**DATE:** December 1, 2022  
**RE:** Village of Irvington  
Architectural Review Board Submittal

**SUBJECT:** **61 FIELD TERRACE:** AMENDED SCOPE OF APPROVED APPLICATION

ALKON YUKELSON  
RESIDENCE

02 EXTERIOR ELEVATION: SOUTH  
SCALE: 1/4" = 1'-0"

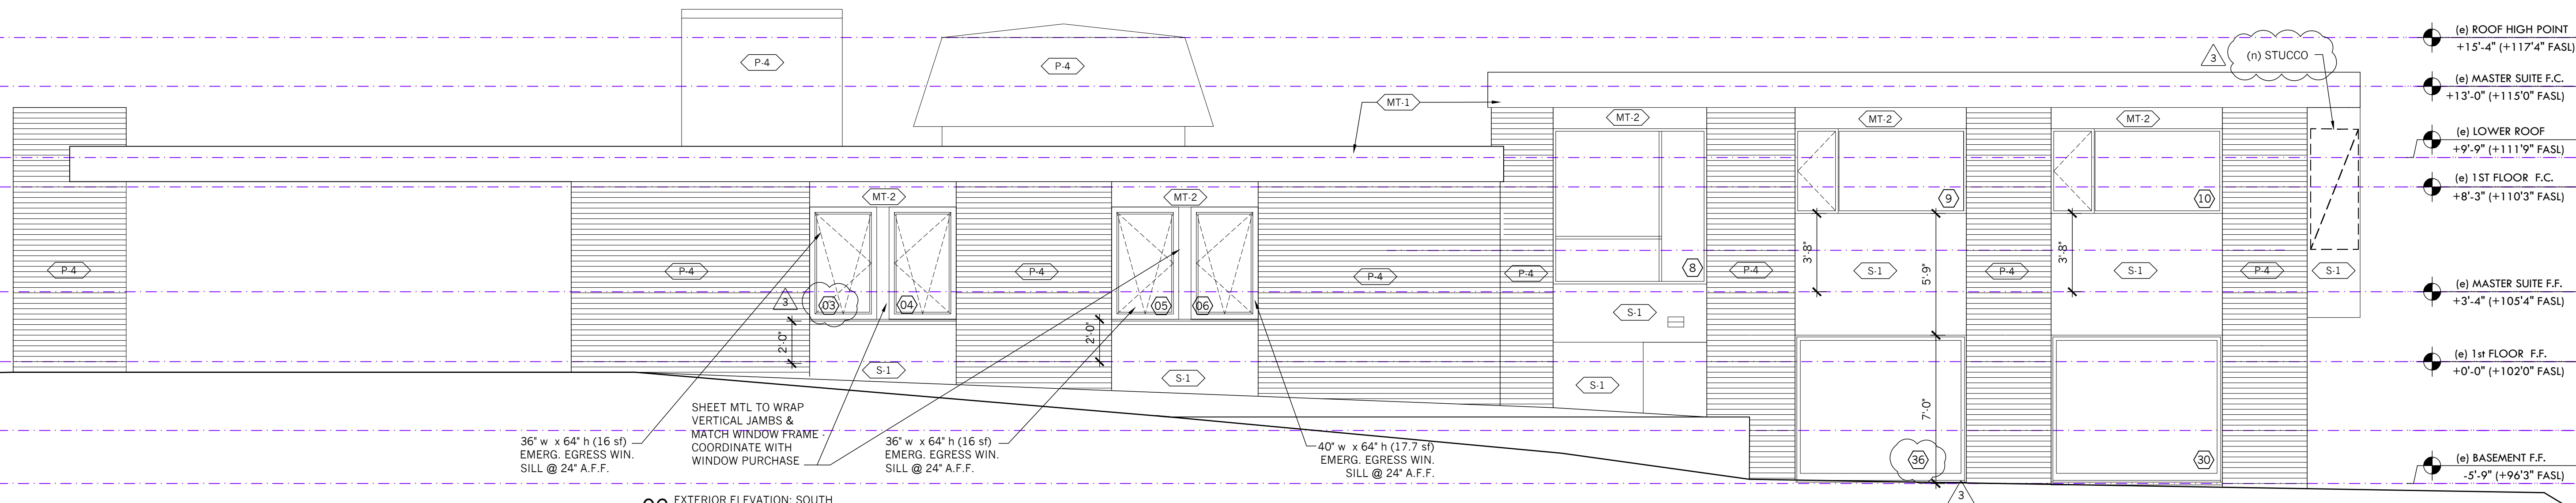
3. Bedroom Window (South). The approved application proposed an enlarged window and the partial removal of the original brick wall. The requested change proposes a new window in the existing opening and leaving the original brick wall in tact.

01 EXTERIOR ELEVATION: EAST  
SCALE: 1/4" = 1'-0"

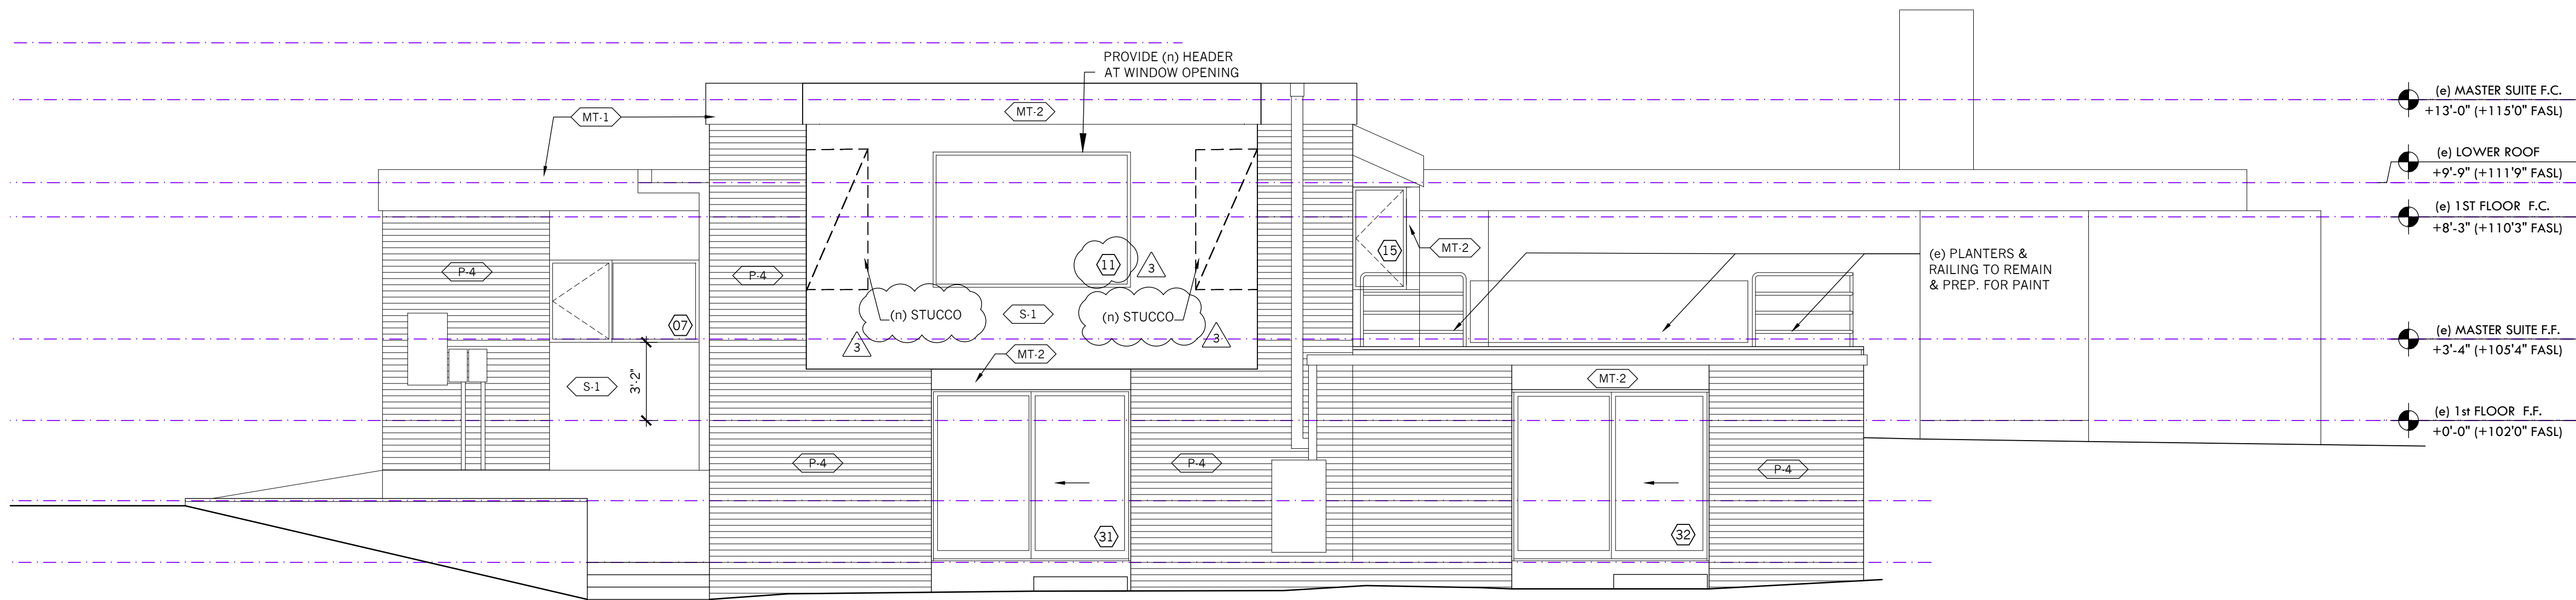
1. Rear (East) façade bedroom window: The approved application proposed new windows in existing locations at the Prime Bedroom. The requested change proposes infilling the existing windows (at the corners) and creating a new opening in the wall. This change will create an improved connection to the landscape at the back of the property and frame the treeline in a more impactful way. It will not be visible at all from the street.
